## **MOORE-SUSSEX PLACE ESTATES SUBDIVISION**

APPLICATION NUMBER 3 DATE August 18, 2016

REQUEST Subdivision

# DETAIL SITE PLAN

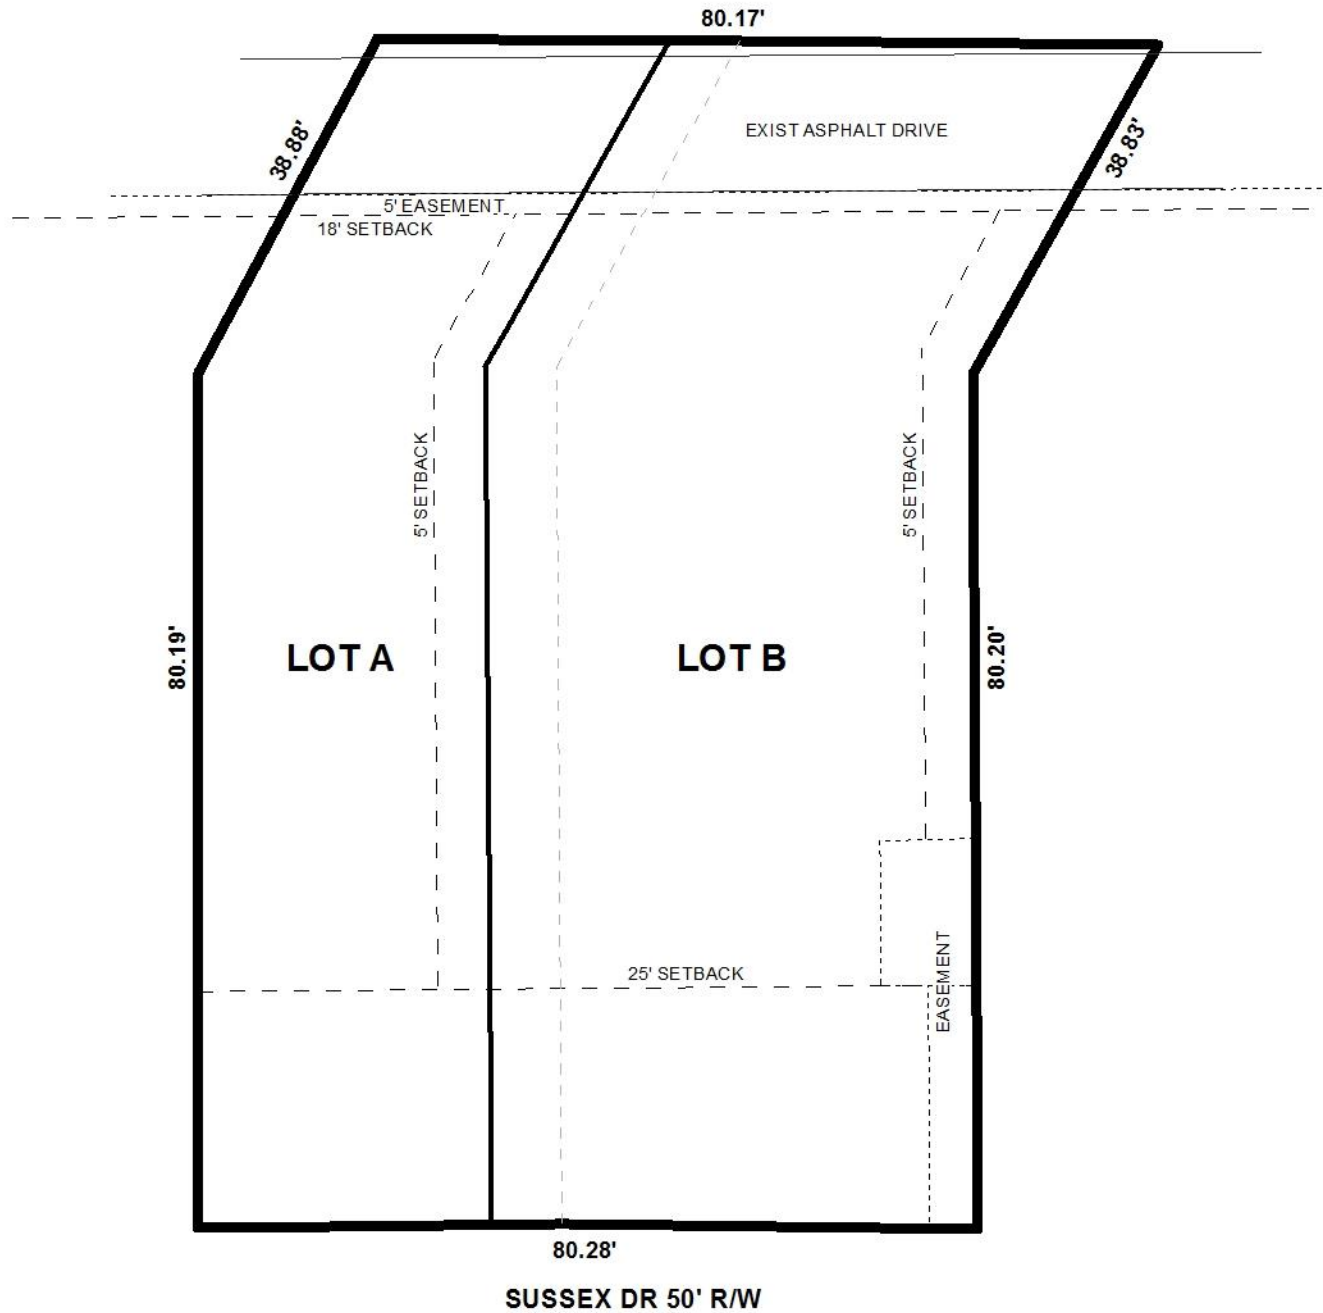
The proposed lots have frontage on Sussex Drive, a minor street with curb and gutter requiring a right-of-way width of 50 feet. The preliminary plat illustrates an existing right-of-way width of 50 feet; therefore, no additional dedication should be required.

It should be noted that each proposed lot is accessed via a private alley in the rear of the property, the result of an 18' reciprocal easement; and, as such, access to Sussex Drive should be denied.

The proposed lots do not meet the minimum size requirements of Section V.D.2. of the Subdivision Regulations; however, a waiver of Section V.D.2. may be appropriate due to previous approval of substandard lot sizes at this location, as well as previous subdivision approvals establishing substandard lots in the immediate vicinity. The lot sizes are illustrated in both square feet and acres, which is information that should be retained on the Final Plat, or a table furnishing the same information should be provided, if approved.

The 25-foot minimum building setback is illustrated on the preliminary plat. If approved, this information should be retained on the Final Plat.

With regards to a note on the preliminary plat stating the lots are approved for 0' side yard setbacks, the subdivision was originally approved at the November 1, 1979 meeting of the Planning Commission, prior to the adoption of regulations regarding Planned Unit Development; and, as such, similar approval of reduced side yard setbacks may be appropriate. If approved, the note should be retained on the Final Plat.

Finally, in addition to the aforementioned reciprocal easement, there is a 150 s.f. utility easement behind the 25' minimum building setback line and along the East property line of proposed Lot B, as well as a 5' easement within the 25' minimum building setback line also on proposed Lot B; and a 5' gas line easement is illustrated in the rear of both proposed lots. As such, a note should be placed on the Final Plat, if approved, that no structures will be erected in any easements.

Based on the preceding, and with a waiver of Section V.D.2., the plat is recommended for Approval subject to the following conditions:

- 1) placement of a note on the Final Plat stating that lots A and B are denied access to Sussex Drive;
- 2) retention of the lot sizes in square feet and acres on the Final Plat, or the furnishing of a table on the Final Plat providing the same information;

- 3) retention of the 25' minimum building setback line on the Final Plat;
- 4) a note placed on the Final Plat stating that no structures will be erected in any easements;
